SUNDRY NOTICES AND REPORTS ON WELLS
1. Type of Well: Oil Well [x] Gas Well [] Other []
2. Name of Operator: BTA Oil Producers LLC
3. Address of Operator: 104 S. Pecos, Midland, TX 79701
4. Well Location: Unit Letter L; 1980 feet from the South line and 330 feet from the West line. Section 11, Township 23S, Range 28E, NMPM, Eddy County.
11. Elevation: 2990' GL

Purposed P&A

CONDITIONS FOR PLUGGING AND ABANDONMENT

Revised		Producing Well	Drawn	TJW
Bob Hall	10/19/2020	LEASE: 8808 Pardue B #7		3/20/2012
		FIELD: East Loving		
		LOCATION: 1980' FSL 330' FWL Sec. 11 T23S R28E	Approved	
		COUNTY: Eddy STATE: New Mexico		
		PRODUCING FORMATION: Brushy Canyon	Date	
		BTA Oil Producers		2019 Recompletion

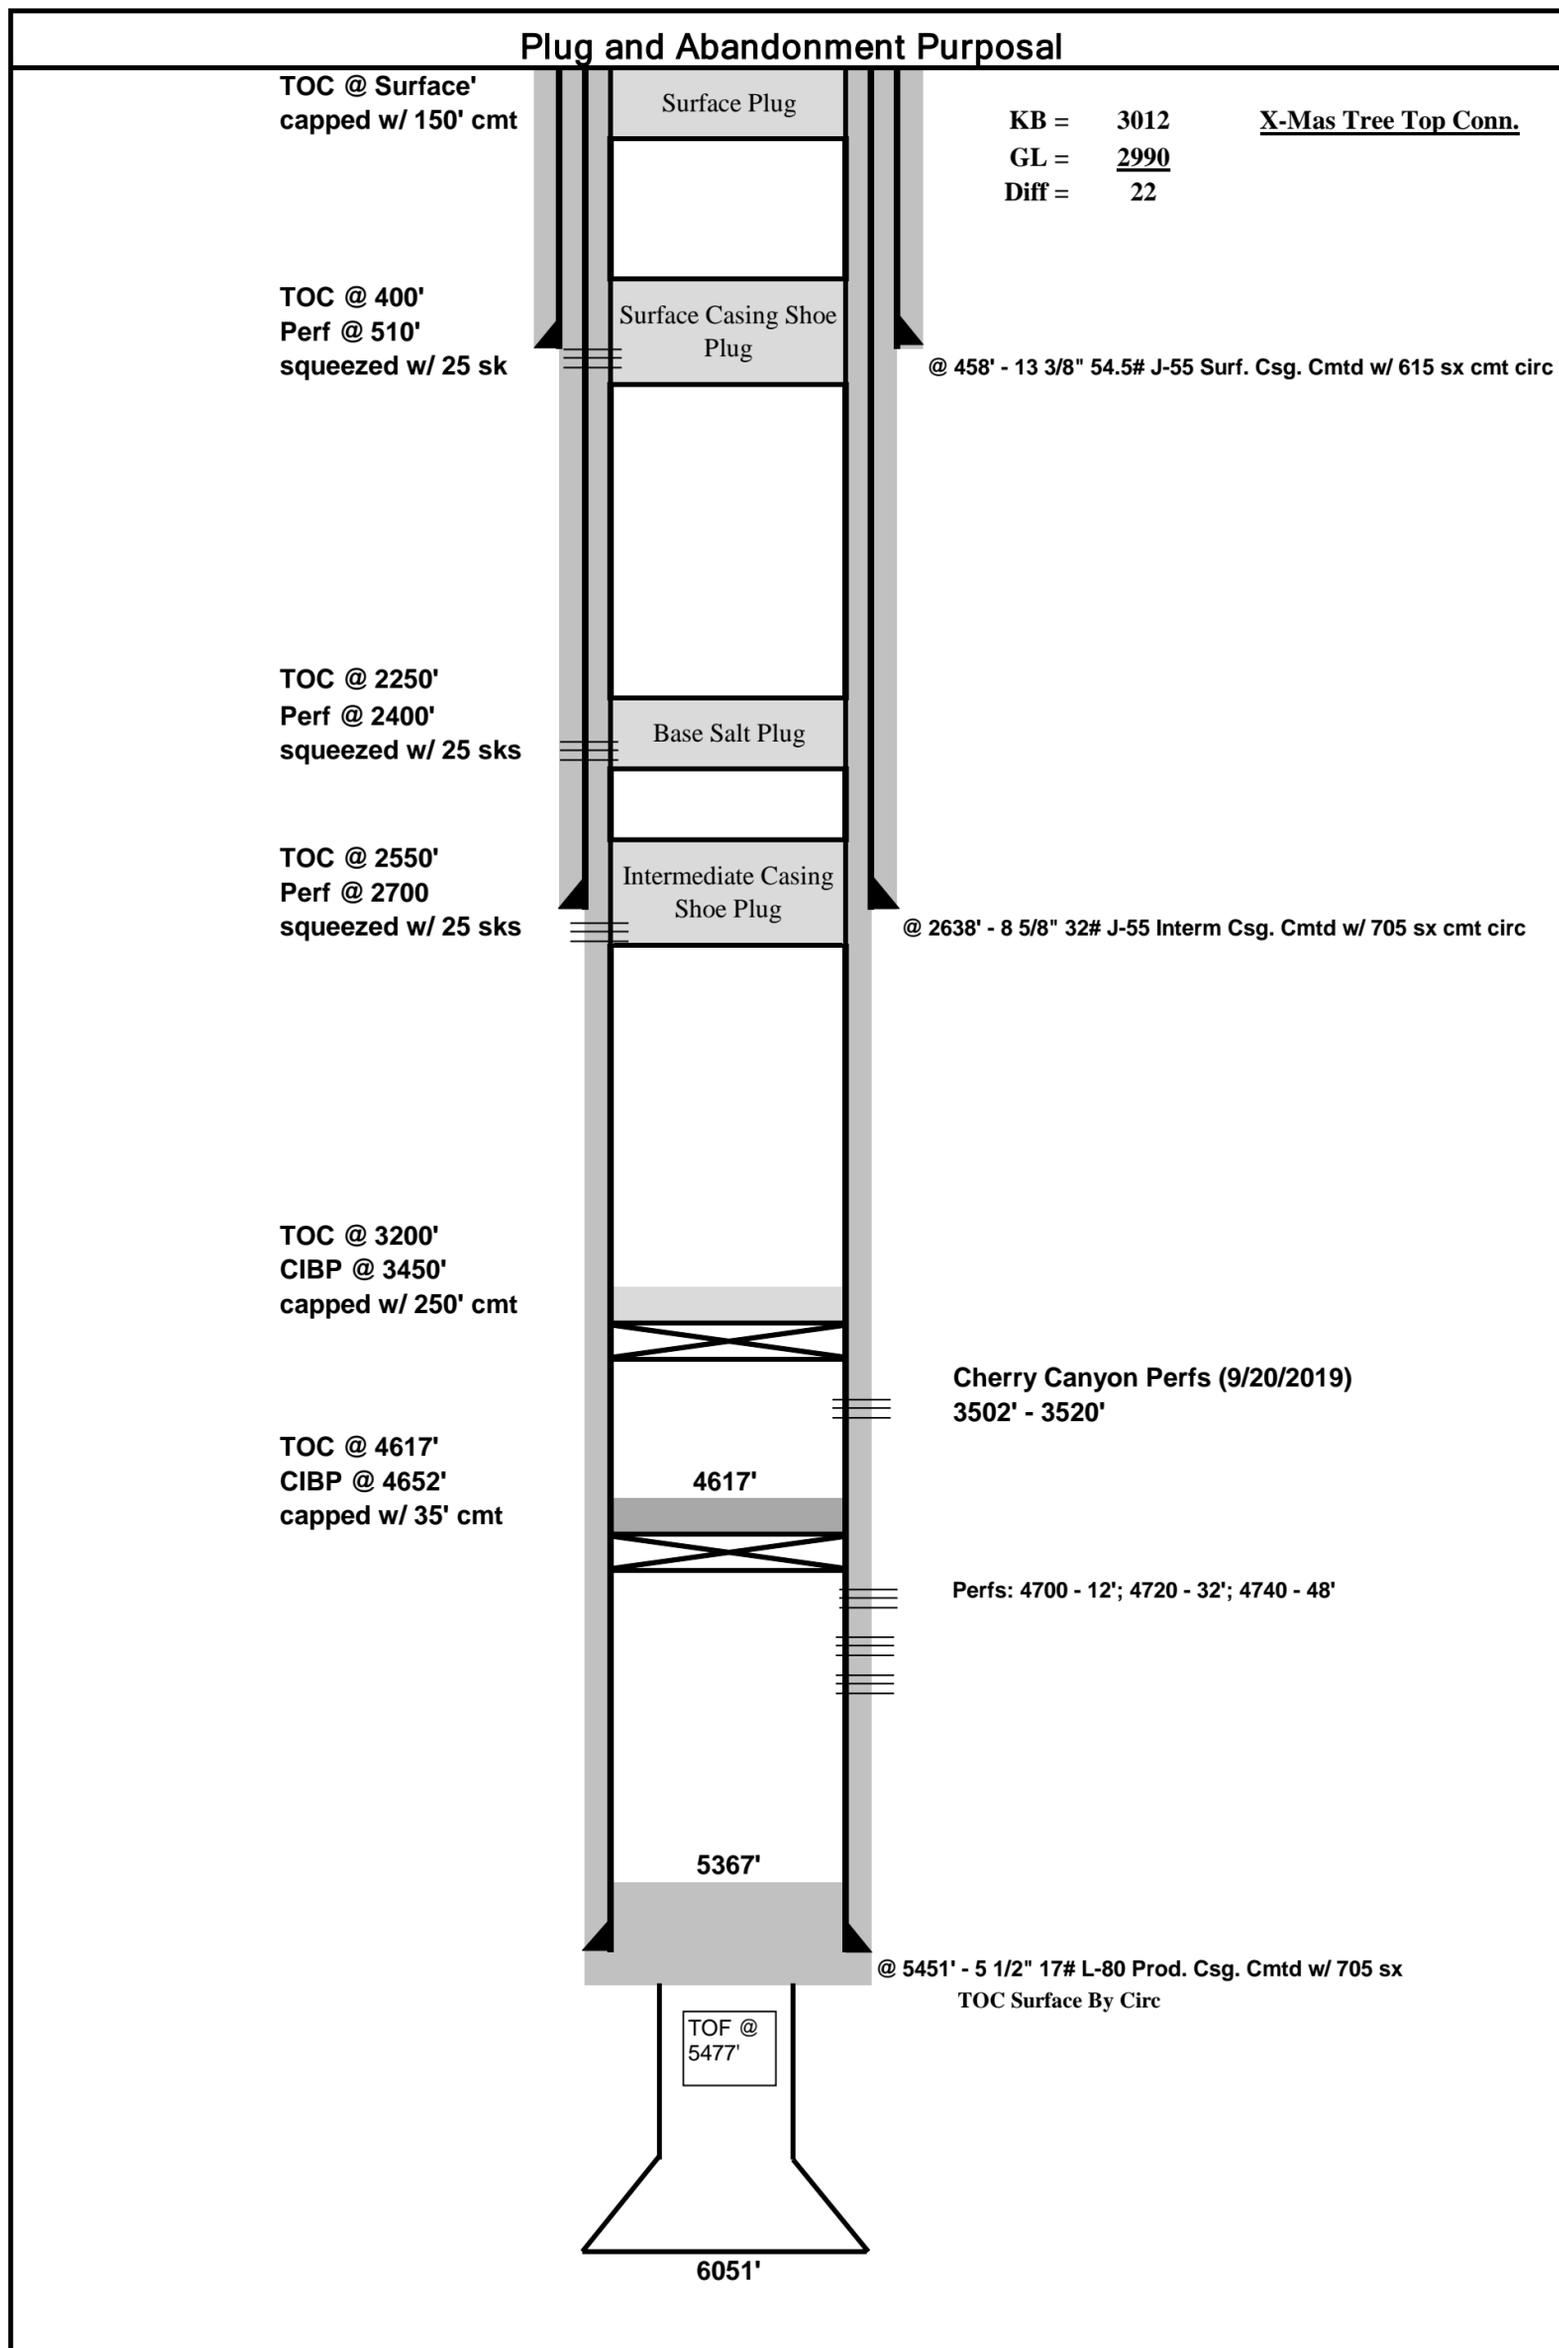
MUST BE PLUGGED BY 5/12/2022

Perf @ 2688'
